Product Change Notification - KSRA-08FGXS912

CCB 3953 Final Notice: Implement new paper tape packing material for selected products available in 3L TO-92 package at MTAI assembly.

PCN#: KSRA-08FGXS912
Pre and Post Change Summary

PCN #: KSRA-08FGXS912

Pre and Post Change Summary

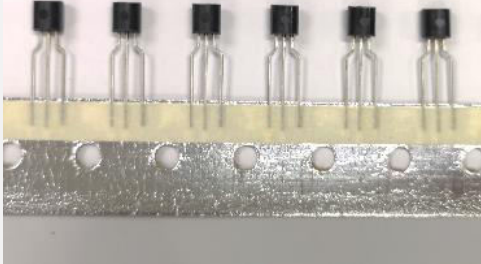
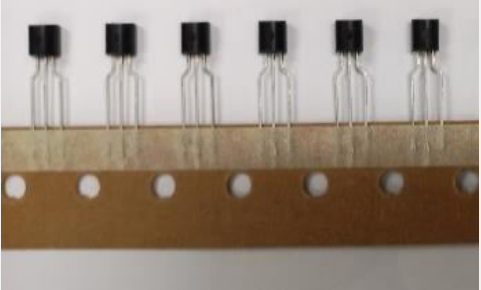
ITEM	PRE CHANGE	POST CHANGE
Material Type	Aluminum Kraft paper	Paper tape
Surface resistivity	< 1.00E+3	< 1.00E+10
Width (mm)	18.00 +0.15/-0.20	18.00 +/-0.20
Thickness (mm)	0.330 +0.020/-0.020	0.470 +/-0.020
Visual inspection
